December 14, 2023 – 6:00 pm Village Hall 235 Hickory Street, Pewaukee, WI 53072

STAFF REPORT

Village of Pewaukee Plan Commission Engineer's Report for December 14, 2023

PRELIMINARY PLANS: DO NOT USE FOR CONSTRUCTION LUETH, CHRIS

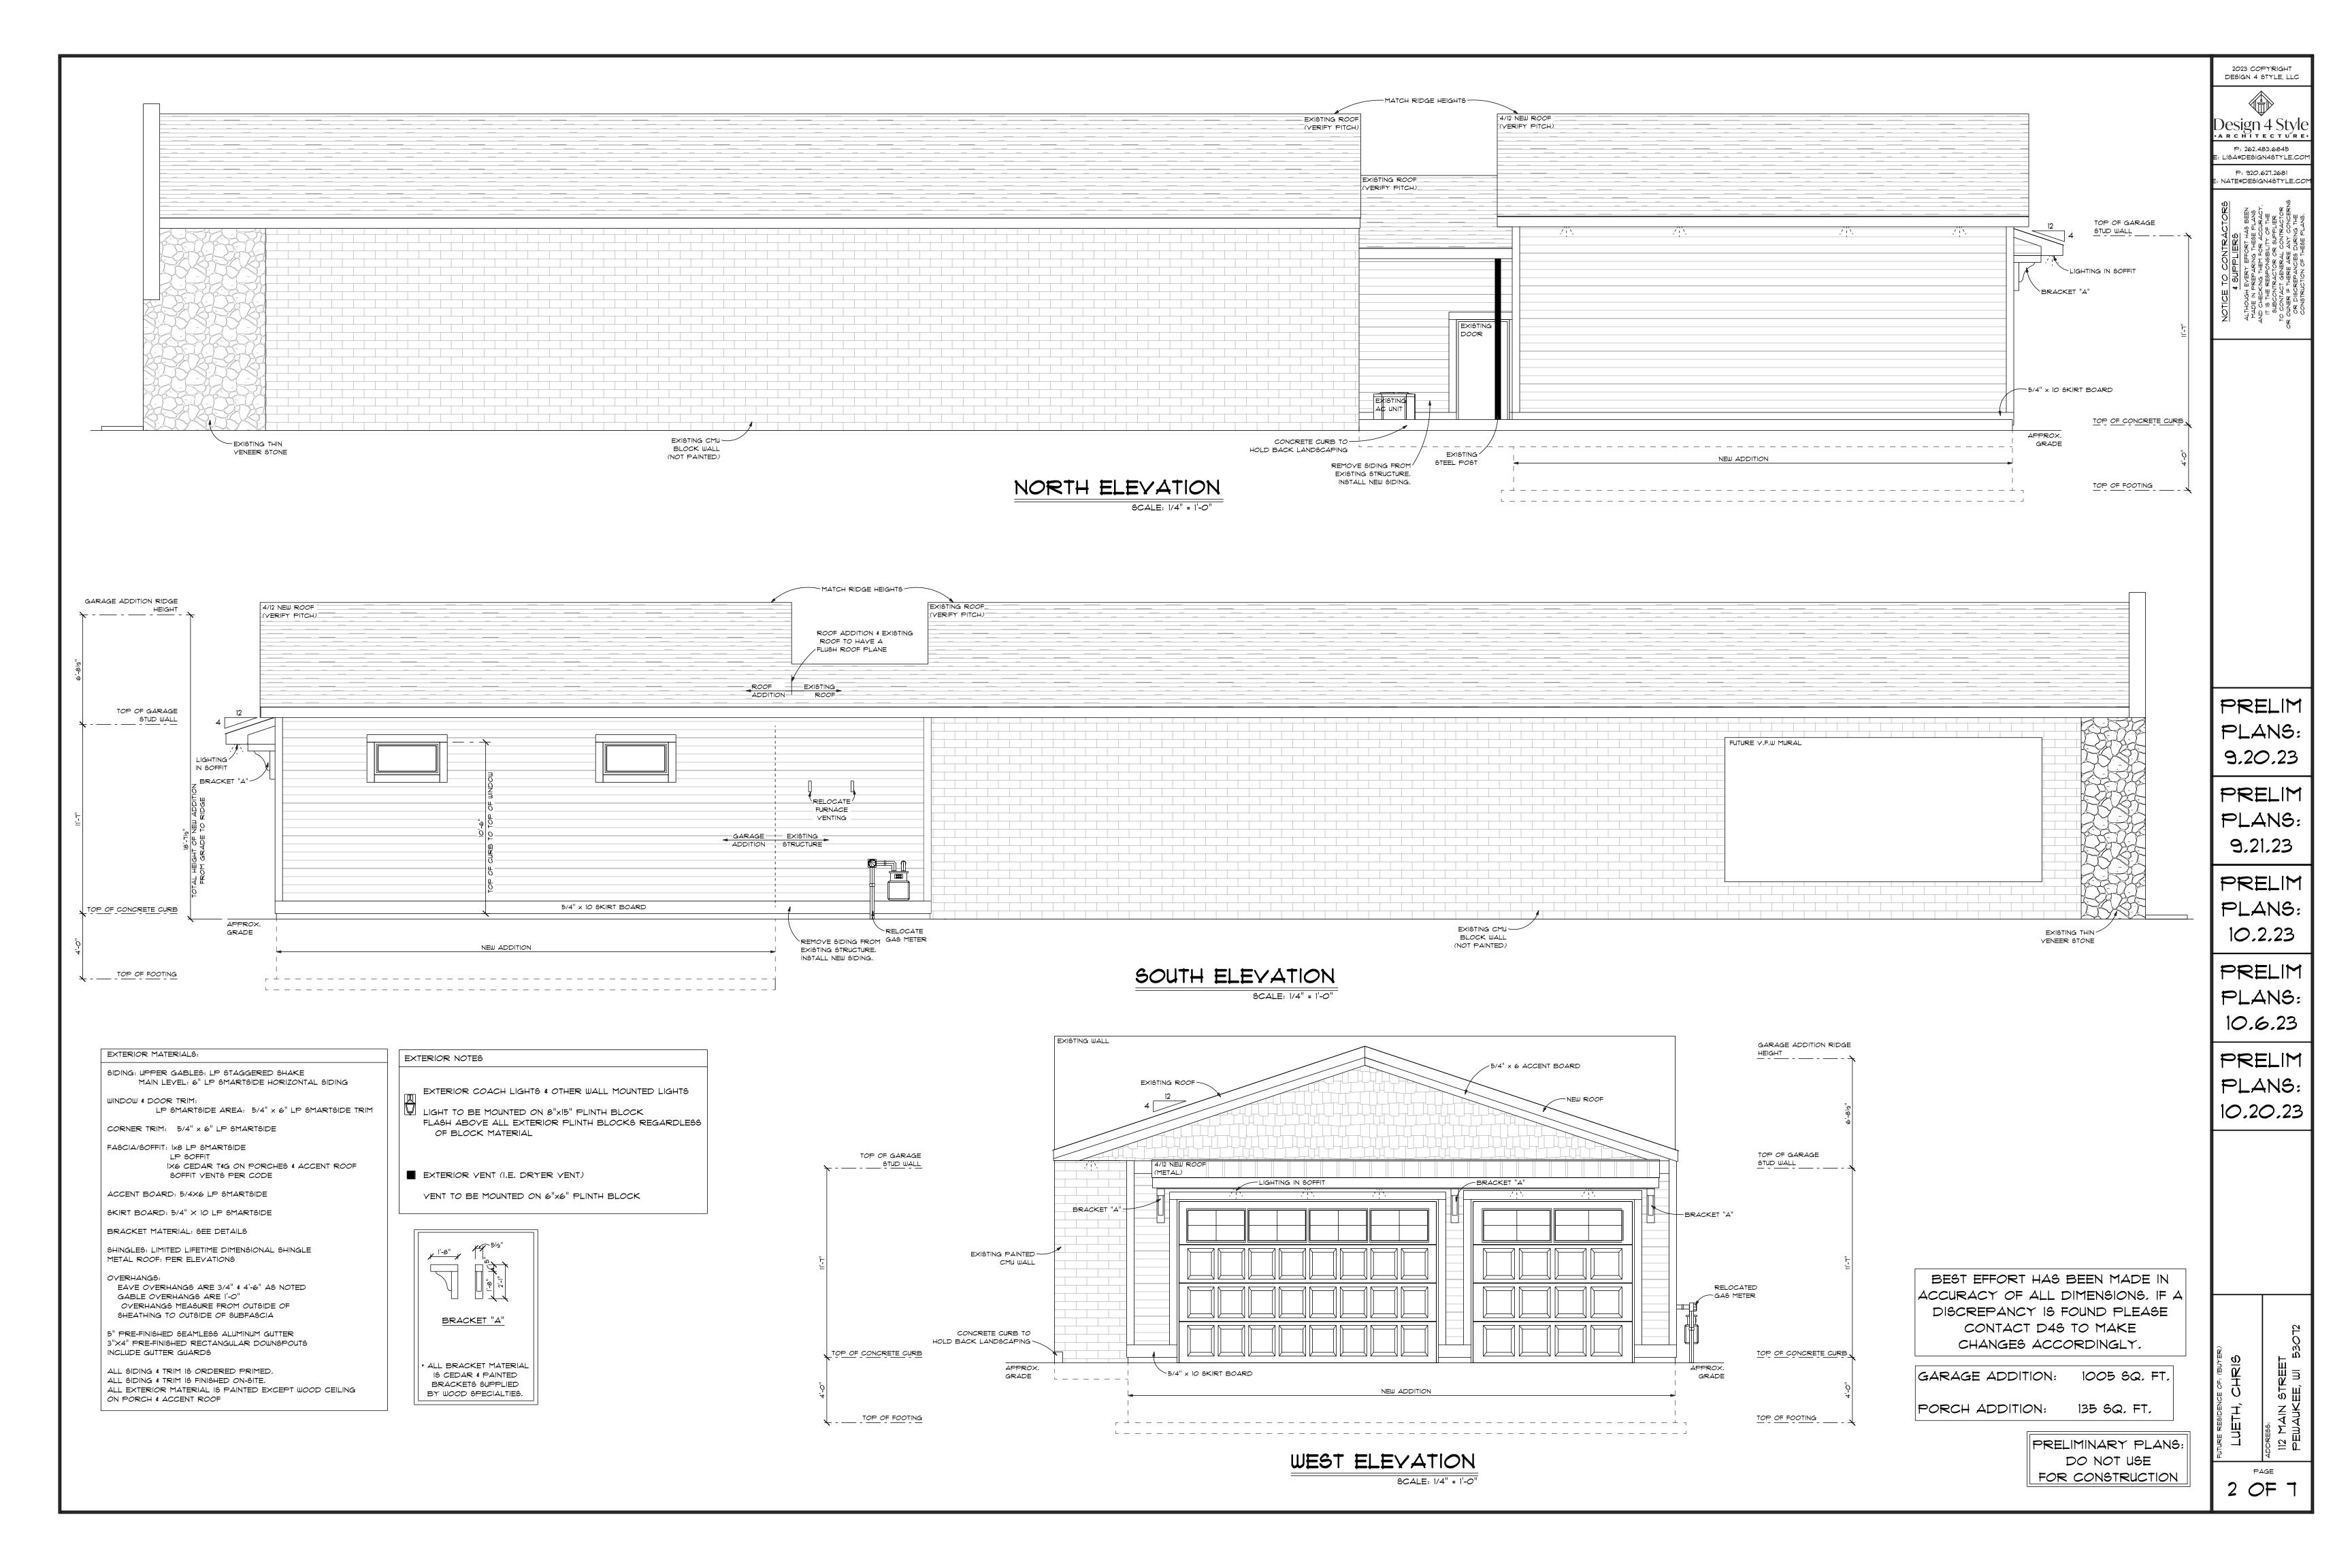
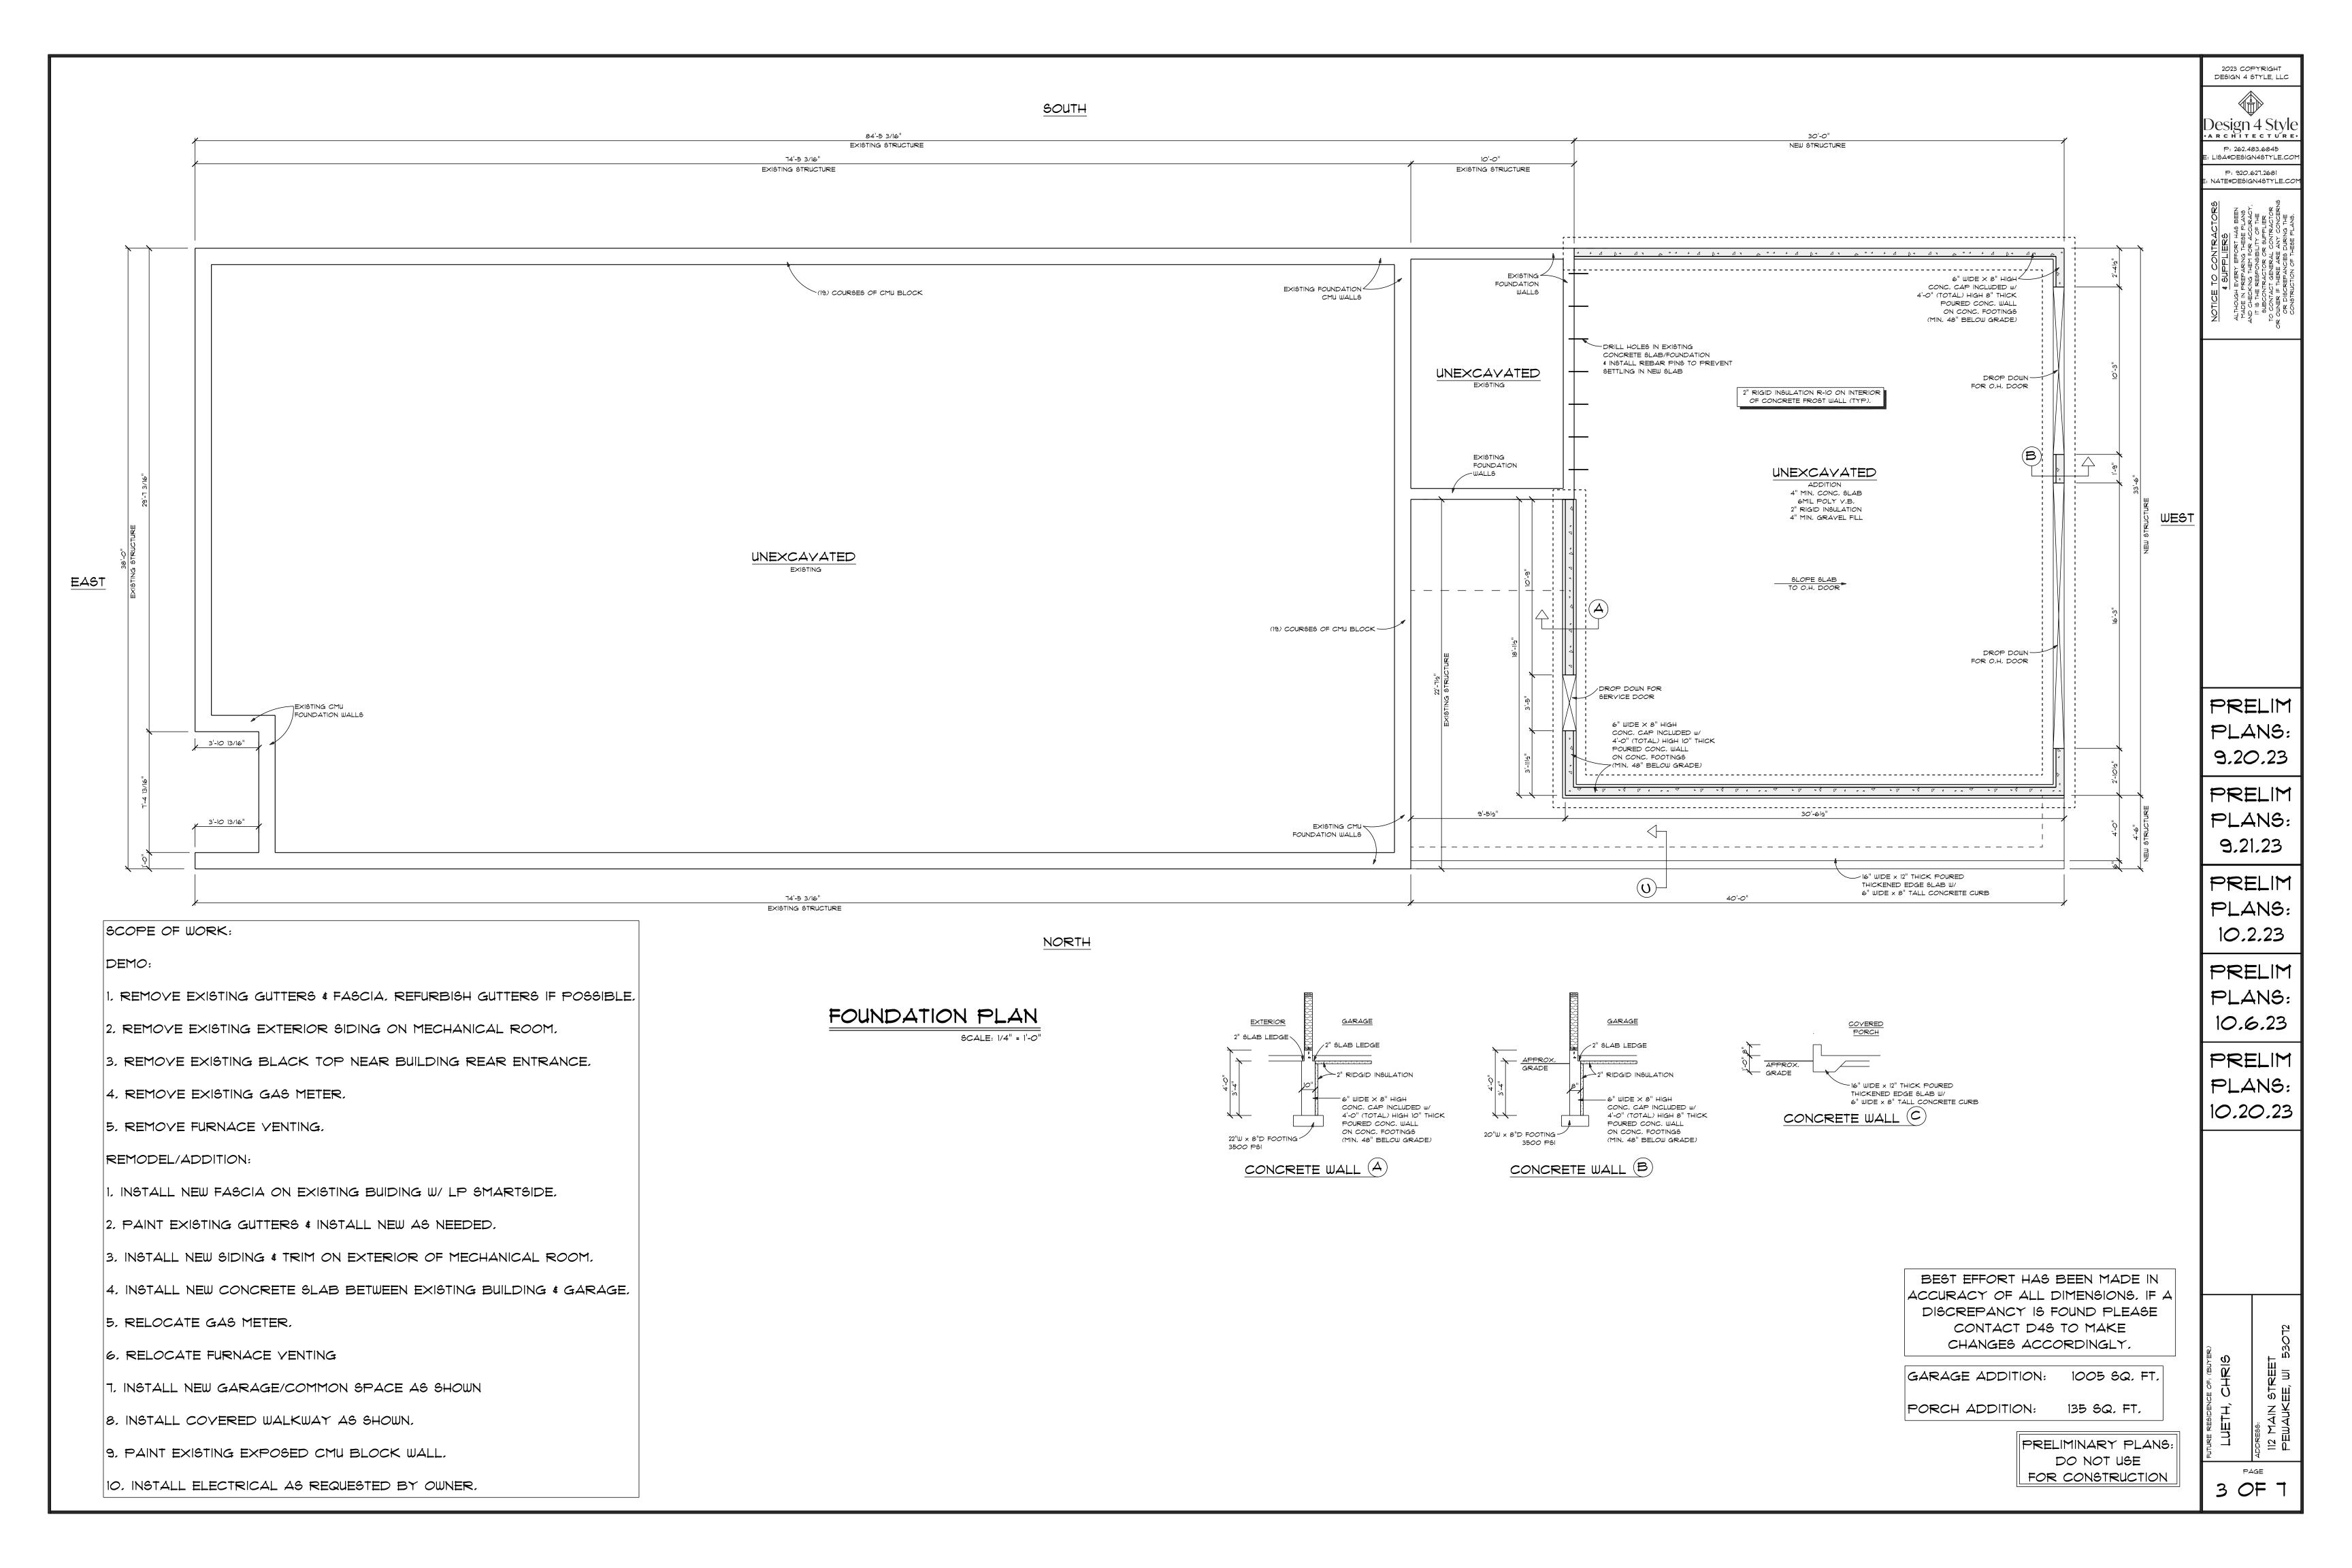
As recently revised, this plan places the addition approximately 2-feet off the south lot line so there is room for the standard soffit overhang and gutter without crossing over property boundaries. As a B-2 district use(s) and/or development on a lot less than 7,000 square feet in size, this is a conditional use. Furthermore, buildings greater than 5,000 square feet in the B-2 District may only be approved through conditional use grant.

Required side yard offset for the B-2 District is 10-feet. The proposed garage addition will not meet this requirement as to sideyards. Waiver or modification of this requirement can be approved by the Planning Commission through conditional use.

The owner is requesting to construct a new garage west of his existing building on Main Street. The building will be placed in a location where there is existing asphalt. Three existing public parking spaces in the parking lot will be removed to construct the garage. The garage will be available for three vehicles according to the submitted plans.

- The owner install gutters and downspouts on both the north and south sides of the roof and discharge the water onto the applicant's property in order to maintain the current runoff pattern.
- The owner provide proof of access permission from adjacent property owners north and south
 of the subject property since the building is on or close to the property line and he will need
 access for equipment and personnel to construct the building.
- Consideration and resolution of any comments heard at the public hearing.
